Plan Commission

Agenda

Monday, March 23, 2020	7:00 PM	De Pere City Hall Council Chambers
------------------------	---------	------------------------------------

SUBJECT: Staff recommendation and possible action regarding a Site Plan request for a new ten-unit apartment with a parking lot at 261 N Lawrence DR (Parcel WD-VA450-1).

SHEET
C-5
OF
C-7

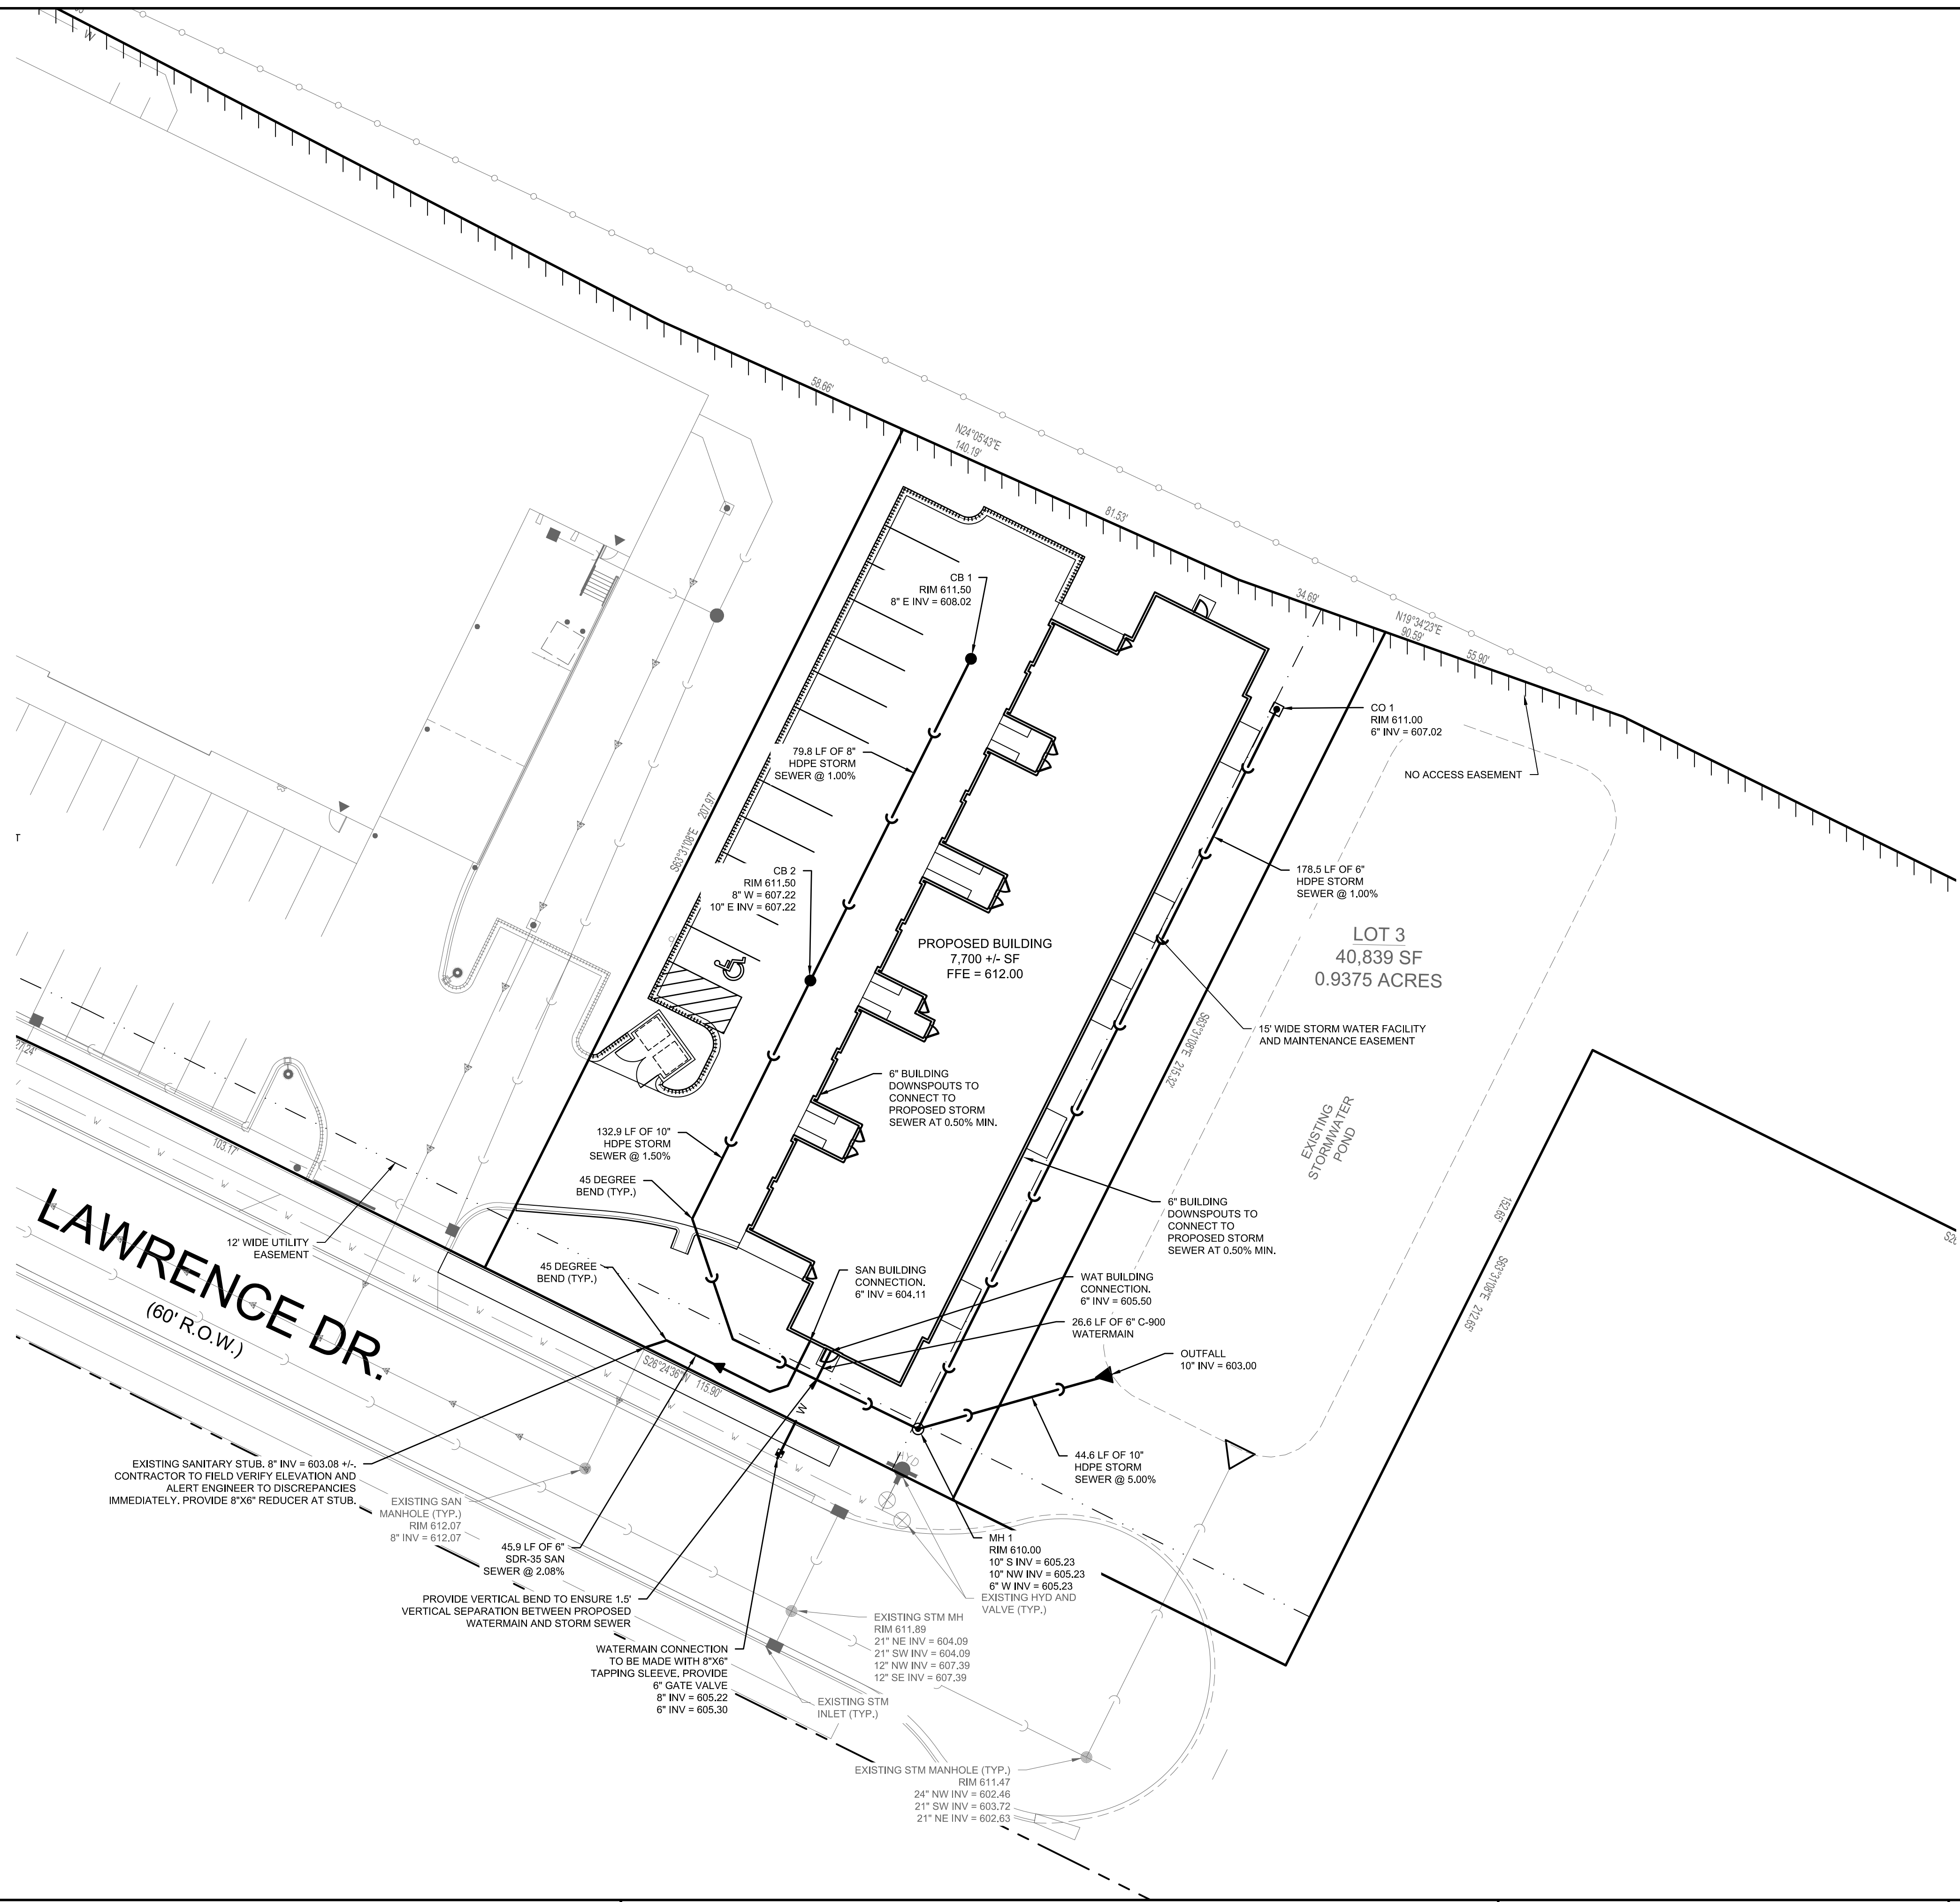
5. Sheet C-5: Site stockpiles should be clearly shown with applicable erosion control.
6. Sheet C-5: Provide WisDNR soil loss sediment discharge calculations with the corresponding map.
7. Sheet C-5: Provide additional elevations for curb and gutter in the parking lot.

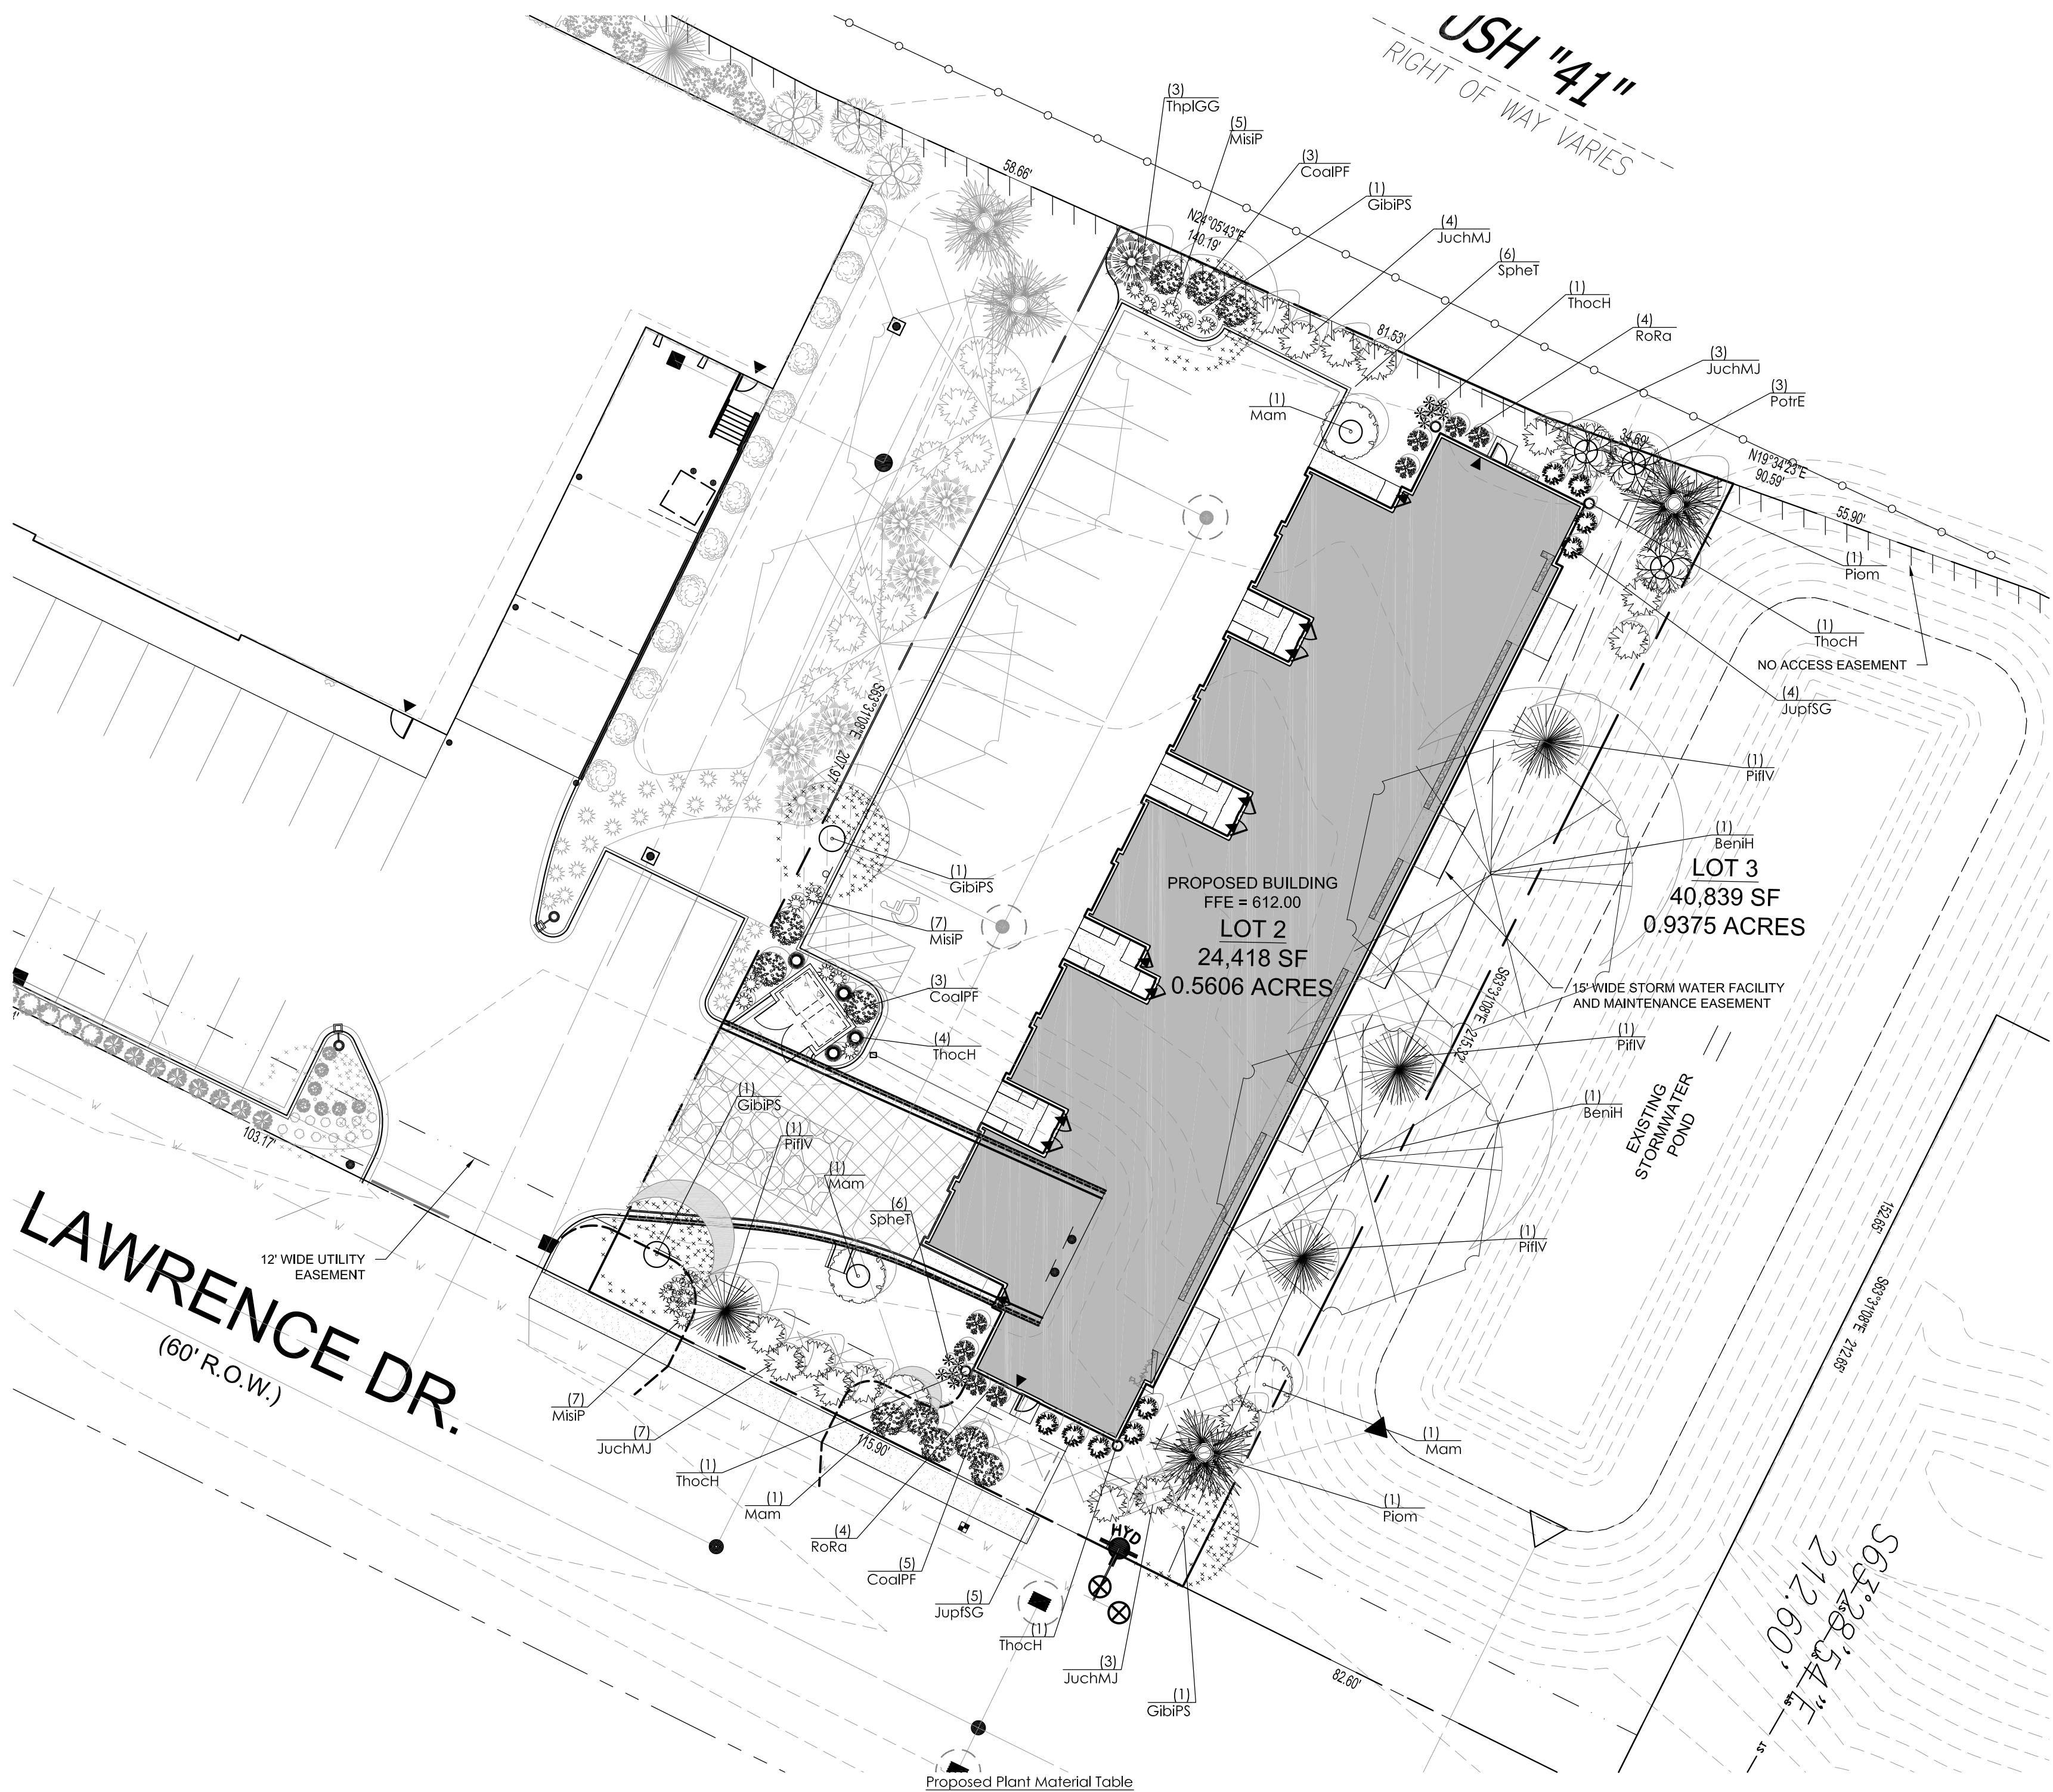
1. No planting plan included with WDNR recommendations. Submit with revised plans.
